REGIONAL FARE COORDINATION SYSTEM

CHANGE ORDER NO. 32

CONTRACT NUMBER:

229944

Figure III-4.1 (KCM)

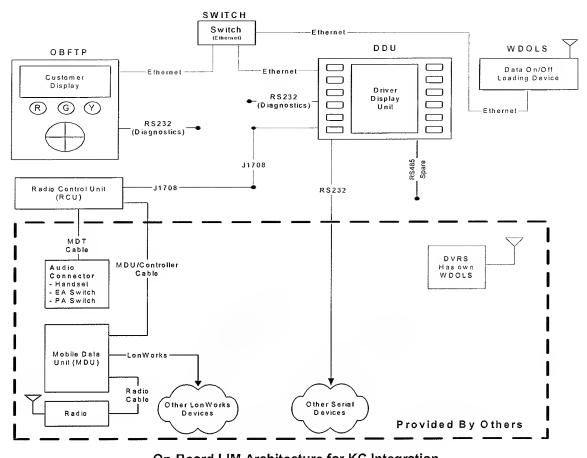
4.1.1 Limited Integration Mode (LIM)

In the Limited Integration Mode, the OBFTP shall store transactions until communication with the WDOLS is established and data transfer can be completed. The OBFTP shall connect to other on-board devices as illustrated in Figures III-4.1 and III-4.2.

Figure III - 4.3 (KCM - revised by C.O. 32)

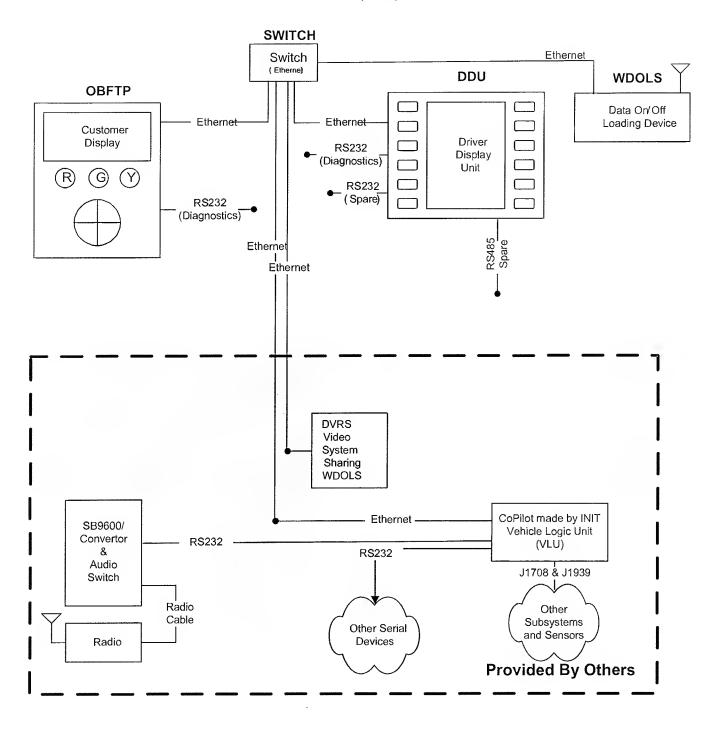
2.1 Section 6.III-4.1 is amended to read as follows:

4.1.2 Full Integration Mode (FIM) - King County

In the Full Integration Mode, the VLU, DDU and the OBFTP shall share the use of the WDOLS for coaches owned or operated by King County. When communication is established via the WDOLS, then the data transfers for each device will be handled in parallel until all are completed. The OBFTP, DDU and WDOLS shall be connected as illustrated in Figures III-4.3 and III-4.4.

The Ethernet switch shall act as the interface between the OBFTP, DDU and VLU. The VLU shall send data and information as described herein to the DDU. The DDU will share the information from the VLU with the (AFC Application) by use of the DDU Common Store. An Ethernet/High Speed Serial interface shall be used for on/off-loading data via the WDOLS. Data provided by the VLU will include the variables described in Section 6.III-6.8.4, including but not limited to: login data (route/run/trip), trip change prompts, fareset changes and, if the ERG option is exercised, Stop ID data. The AFC Application will update the Common Store variables needed by the OBS, including but not limited to: operator login and default trip fareset.

On-Board Architecture (FIM) for KCM Integration
